TO: Park Commissioners
FROM: Kevin Briski, Parks Superintendent *Kevin Briski*
DATE: December 3, 2010
SUBJECT: Comments on the Supplemental Draft Environmental Impact Statement for the Verona Road/USH 18/151 Project

Wisconsin Department of Transportation
**O2 DRAFT SECTION 4(F) EVALUATION AND
UNIQUE AREA IMPACT EVALUATION**

Figure O2.6.1-1 Stage 3 Effects and Mitigation Measures to Britta Park

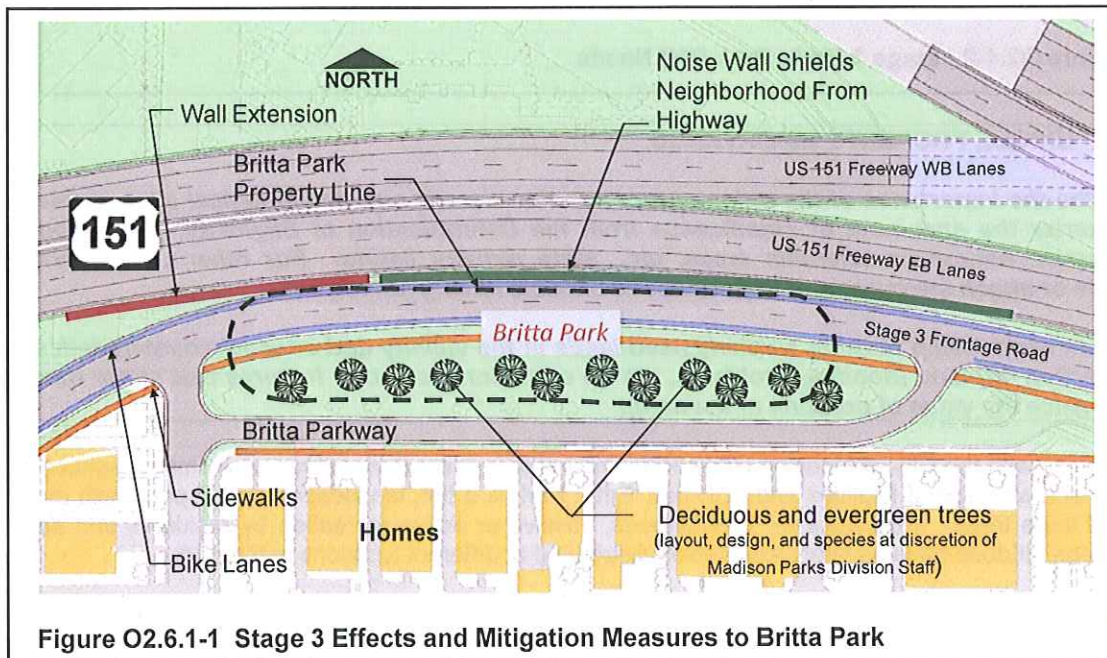
As the SDEIS states, under Stage 1 of the project, the frontage road along the southeast quadrant of the interchange will be relocated. Option A appears to have minor impacts to Britta Park; Option B would allow Britta Park to remain untouched, so it is the preferred option from a parks perspective. If WisDOT's Frontage Road Option B is selected and the buildings abutting the existing frontage road between Whenona Drive and Niemann Place that currently provide noise and visual screening for Britta Park are removed, it is also recommended that a noise wall between the new frontage road and Britta Park be constructed to reestablish the existing screening. If this is not statutorily possible, it is recommended that a visual barrier be created (potentially earth mound and plantings).

According to WisDOT, Stage 3 of this project will be constructed when operation and safety needs warrant the infrastructure investment; it is anticipated that this will occur near the year 2030. It is recommended that the need for Stage 3 of this project, which would potentially require WisDOT to acquire more than 1/2 of Britta Park, be reevaluated before its implementation. The loss of any parkland is detrimental to the health and well-being of the citizens of the City of Madison, particularly in this area of the City where there is a lack of neighborhood park facilities. Both Britta Park and DeVolis Park help to fill that gap. At the April meeting where the three options for Stage 3 were presented, Park Commissioners felt that while they would prefer there would be no loss of parkland, the other alternatives identified (rerouting the frontage road on Britta Drive (essentially cutting off the park from the neighborhood), or discontinuing the frontage road which would require traffic to route through the neighborhood) could not be supported.

Sections of the SDEIS are attached; the full SDEIS can also be viewed at http://www.cityofmadison.com/planning/plan.html#USH12_18DSDEIS. Mitigation recommendations include, in addition to paying fair market value for parkland and seeking replacement parkland opportunities, adding recreational facilities to DeVolis Park. These will be based on community input and subject to

Park Commission approval. These may include, but are not limited to playground equipment and sport court (basketball and volleyball, etc.) facilities. More details regarding these improvements will be provided after community input has been obtained and evaluated, which would occur closer to the implementation of Stage 3 given the projected timing for this stage.

Figure 10 Requested Measures from City of Madison Parks Staff

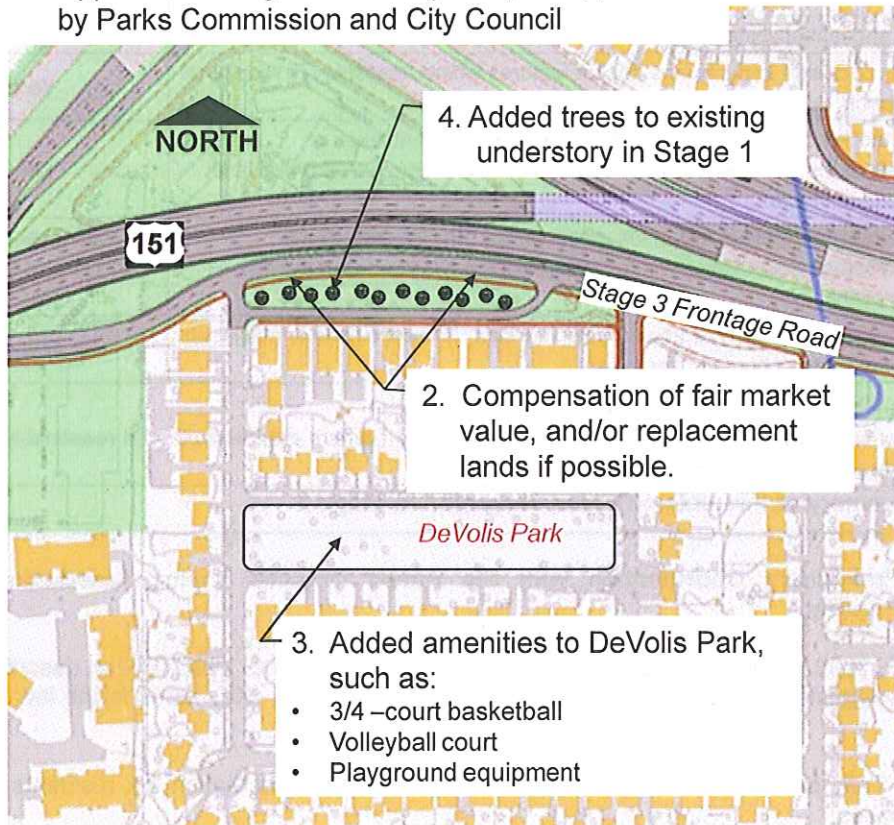
- e. A screening wall may be an acceptable option. The wall could be planted with vertical species to soften its appearance, with a surface that is not conducive to graffiti. The wall could present a "canvas" for public art and this opportunity should be explored further.

- f. There are several measures and requirements to offset impacts to the park. These include:
 - Compensation for the fair market value of the land. Opportunities to provide a one-to-one replacement are preferred if possible.
